Flood Risk Management Team Dumfries & Galloway Council

30 June 2023

Flood Risk Management (Scotland) Act 2009 Newton Stewart Flood Protection Scheme, Newton Stewart, Dumfries and Galloway

River Cree u/s Newton Stewart (ID10520)

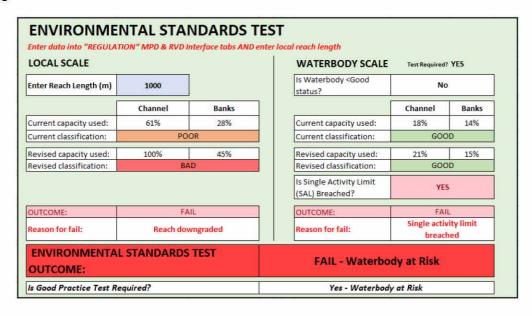
1.4 This waterbody is currently good for morphology. With the new engineering works the water body classification will be impacted by a single activity breach and also a local scale downgrade.

Penkiln Burn (ID10533)

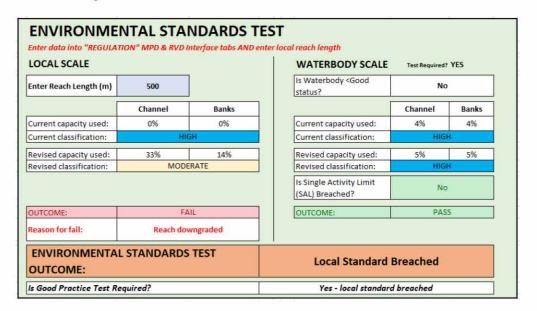
1.5 The Penkiln Burn is currently high for morphology. With the new engineering works there is a local scale downgrade.
